**RE: Westgate Community Center
10001 DeVargas Rd SW
Grading and Drainage Plan
Engineer's Stamp Date: 9/3/19
Hydrology File: M09D030**

Based on the submittal received on 9/3/19, the Grading and Drainage Plan cannot be approved until the following corrections are made:

Re: Westgate Community Center - Hydrology File: M09D030
COA Hydrology Building Permit Approval Re-Submittal

Sheet: Of:
C-001

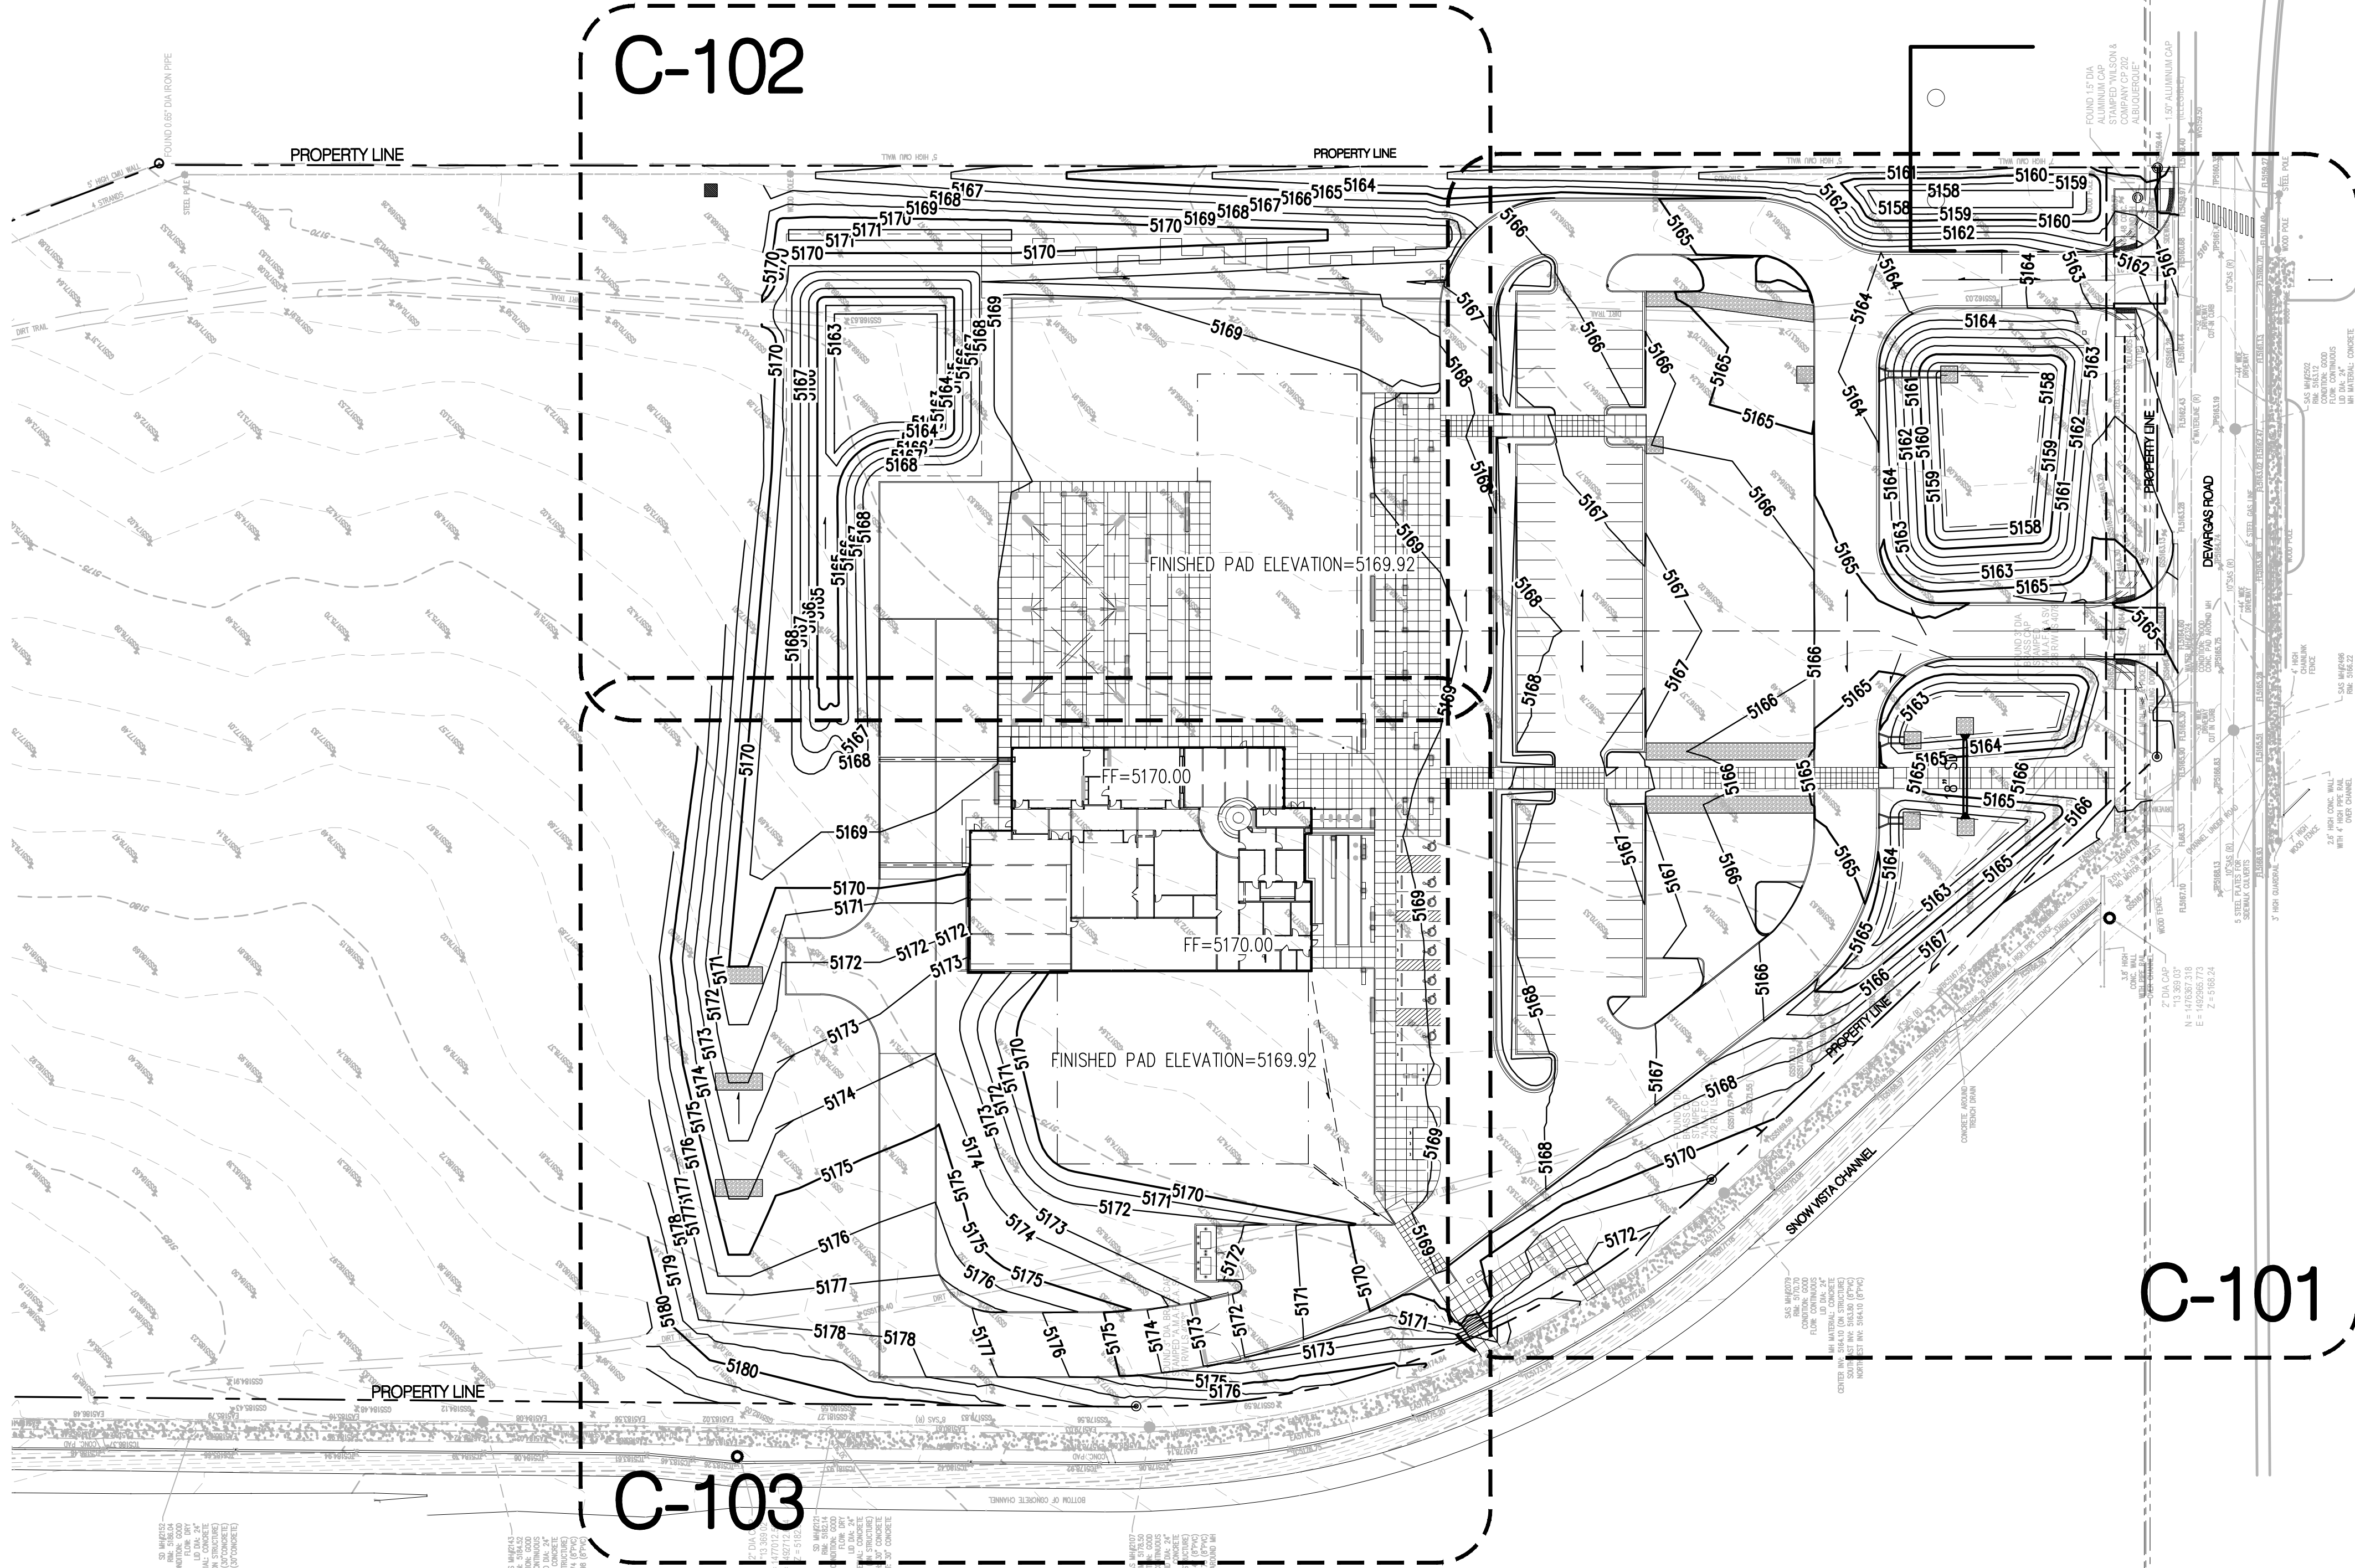
1. Provide an armored emergency overflow from Pond 1; it does not need to be concrete, but it does need to be designed and shown on the stamped grading plan, not the landscaping plan. SW2 is shown in section B-B as a 15' wide swale with unknown depth, but the manning's calculation shows a top width of 45' and a (flow?) depth of 1.63'. The hydraulic calculations must match the section to be constructed. Flow depth needs to be determined in the channel and adequate freeboard provided. Spillway flow depth needs to be determined via the weir equation and adequate freeboard provided along the south and east sides of the pond. Future buildings need to be considered in this design.

By:	Sheet:	Of:
File:	C-100

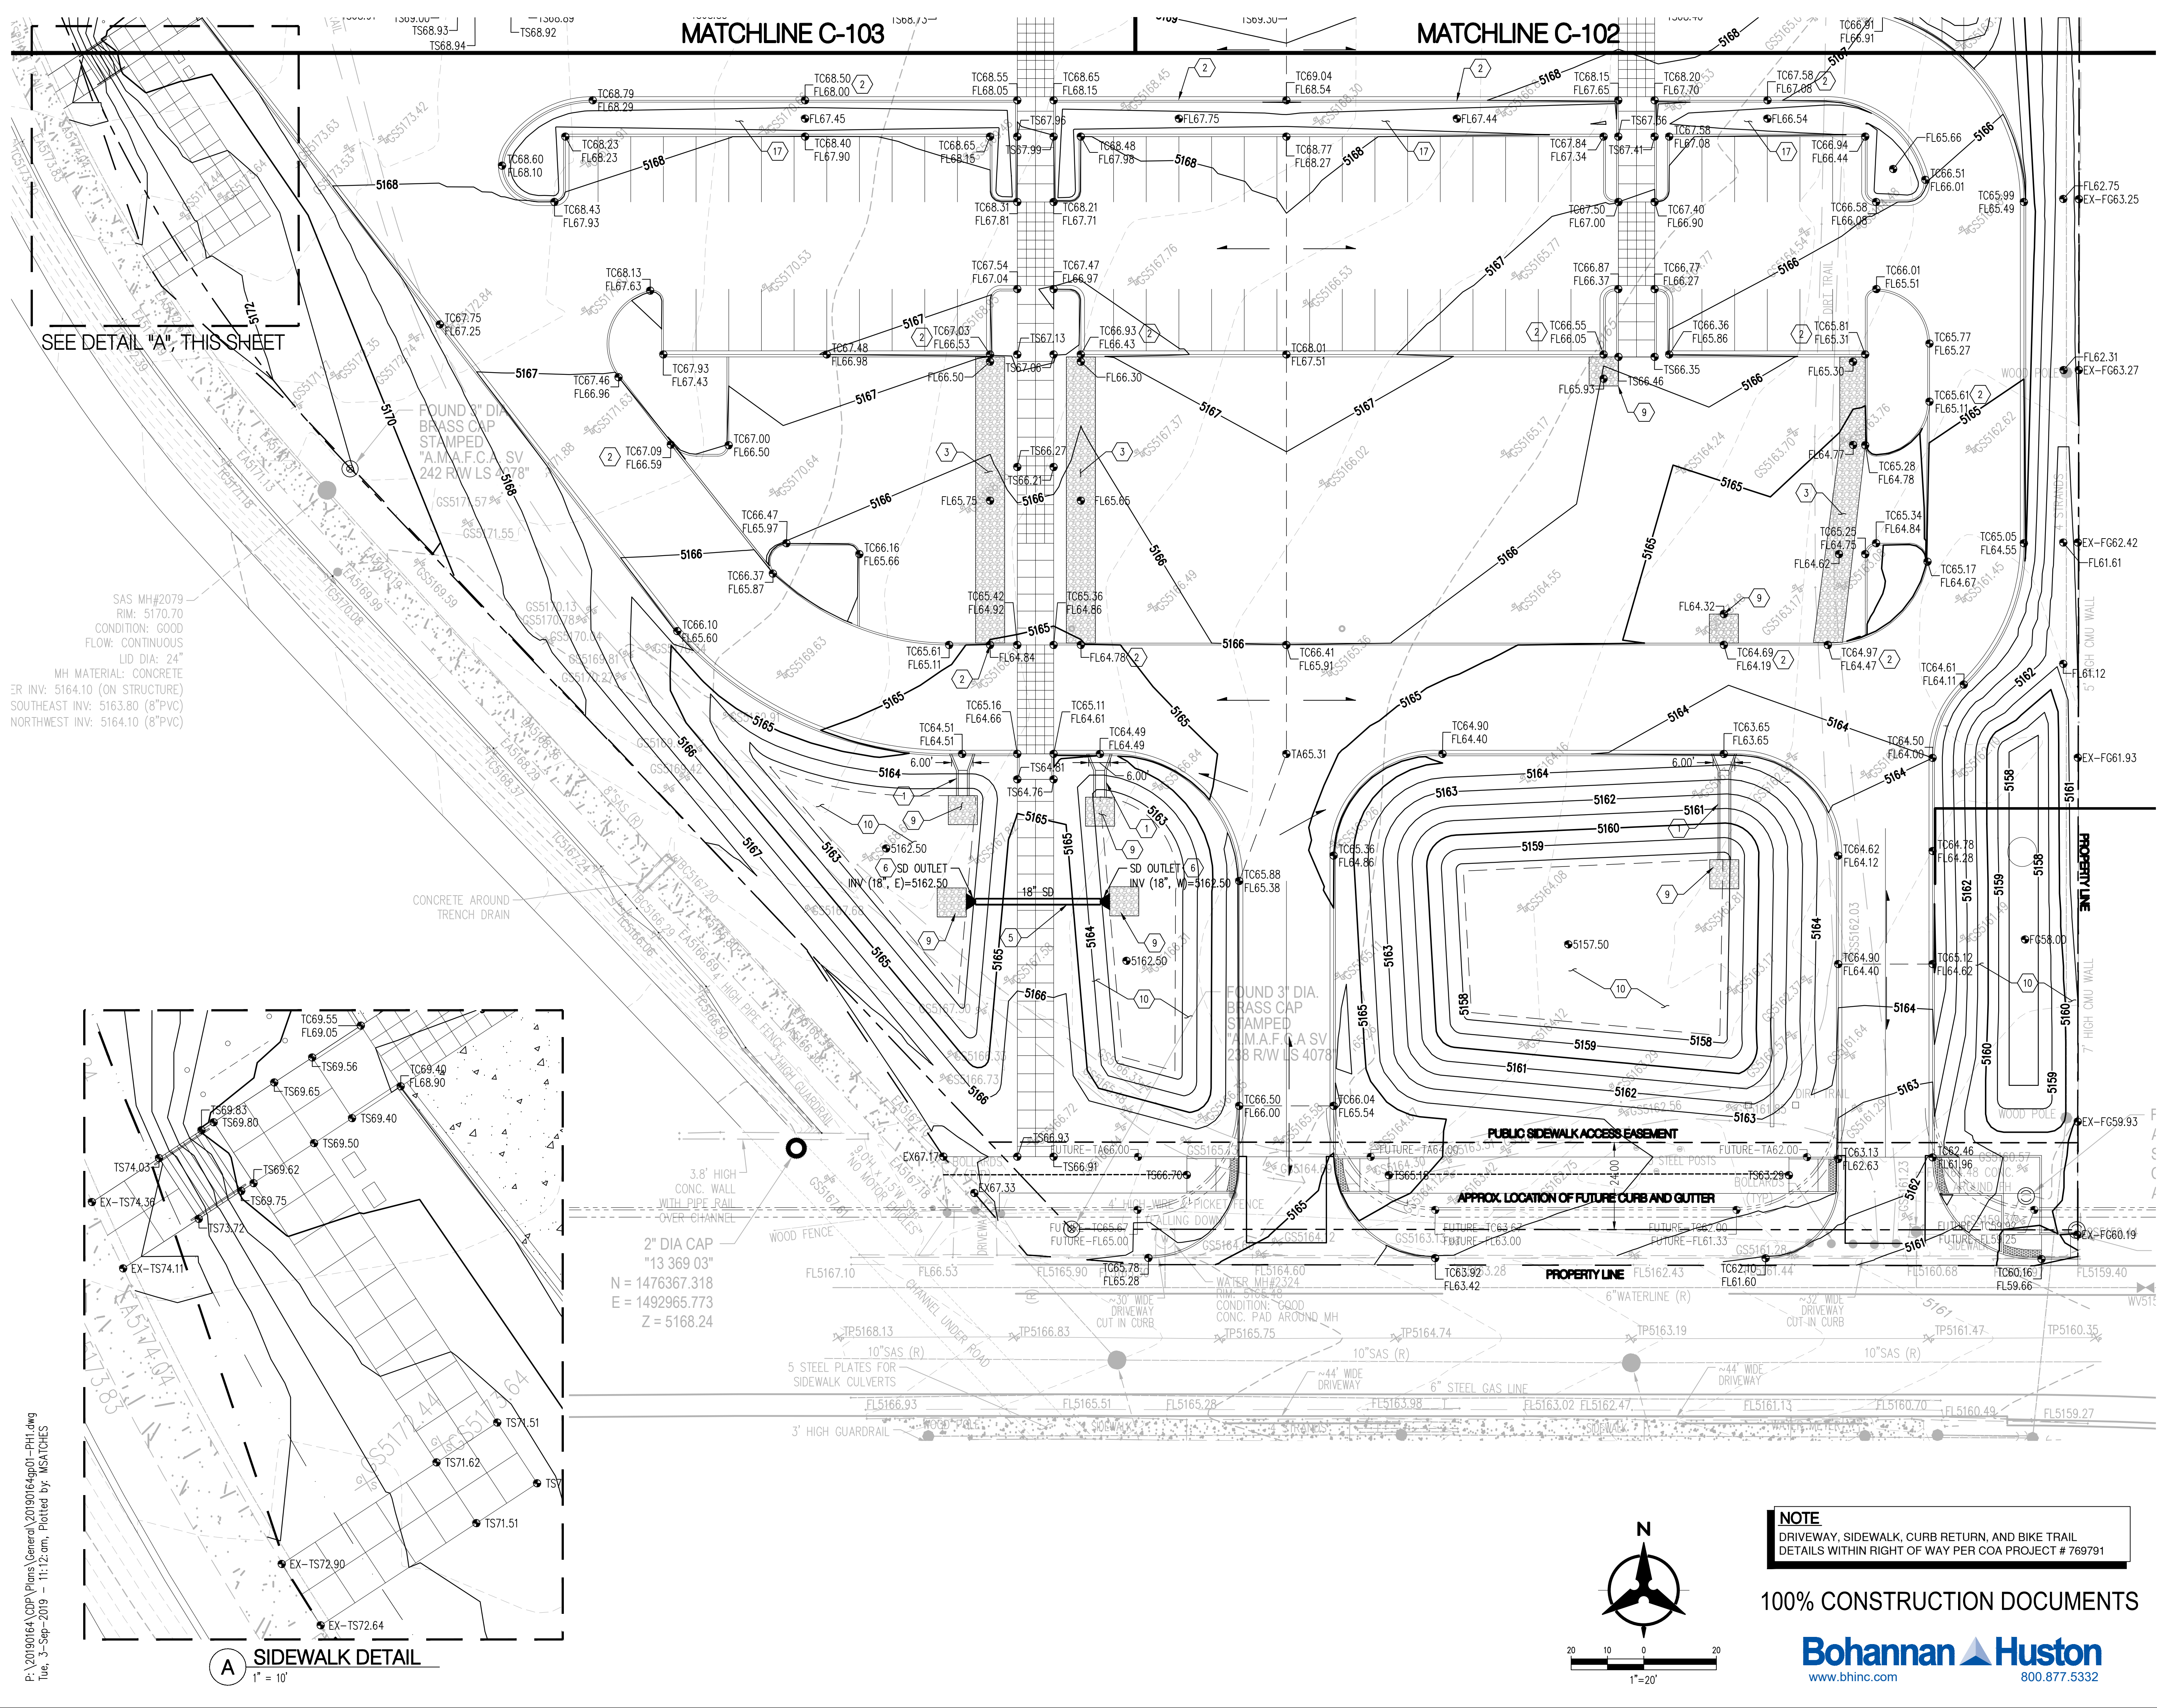
3. Slope stabilization needs to be called out around the western future building pad as well as the berm/swale along the east property line; it may be more reasonable just to reword the general note on C-100 to say "reseed all disturbed areas, including staging areas, per CoA spec section 1012."

G CHECK DAM
NOT TO SCALE

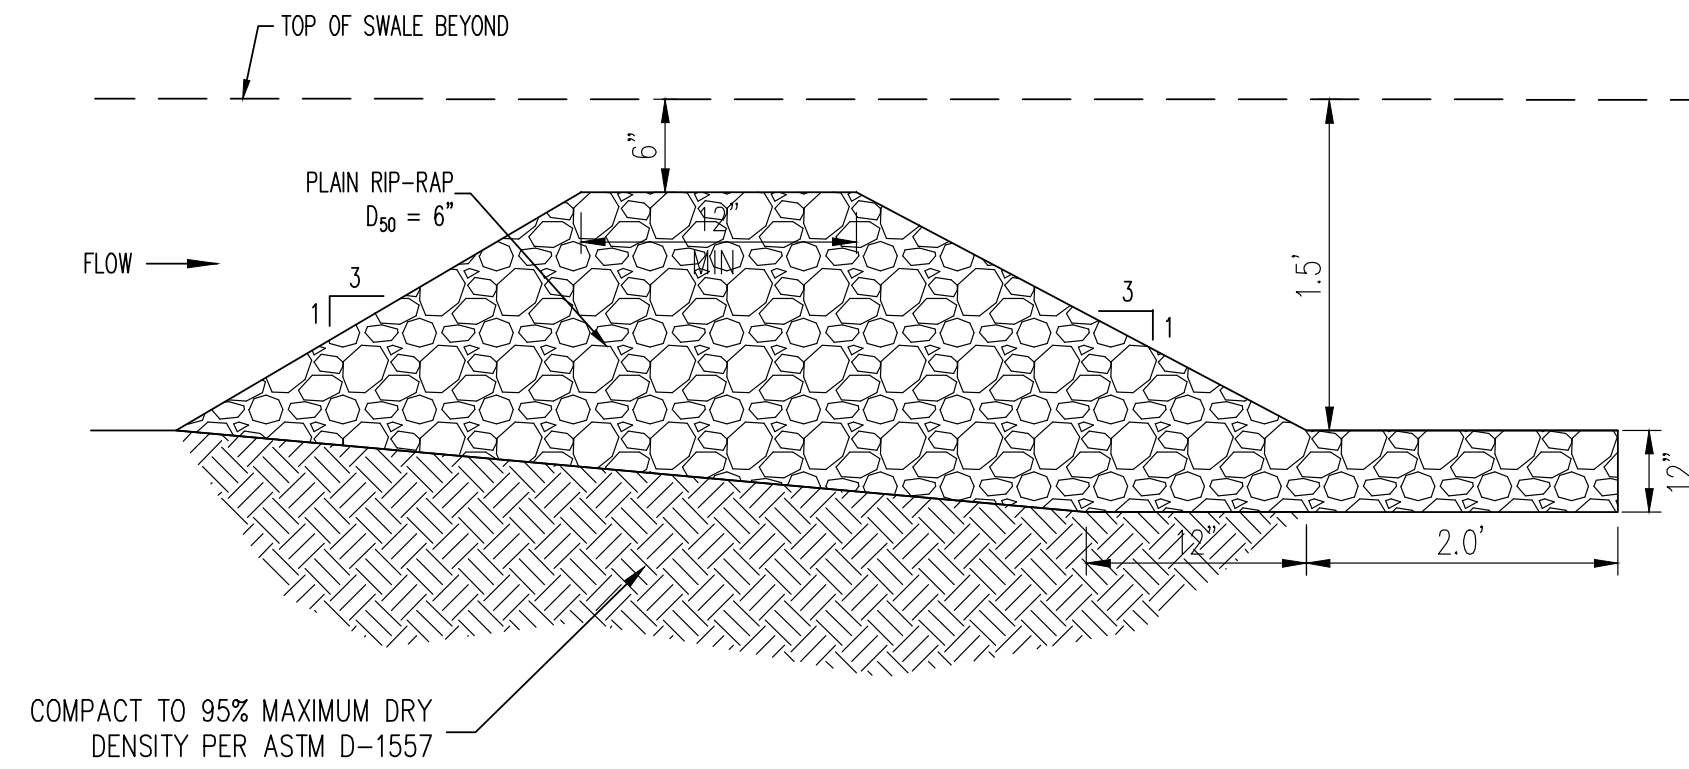
2. Check dams need to be sized and spaced such that the toe of the upstream dam equals the crest of the next downstream dam and provide a sag at midpoint. See NMDOT standards and specifications for temporary erosion and sediment control measures for more details and design standards regarding check dams.
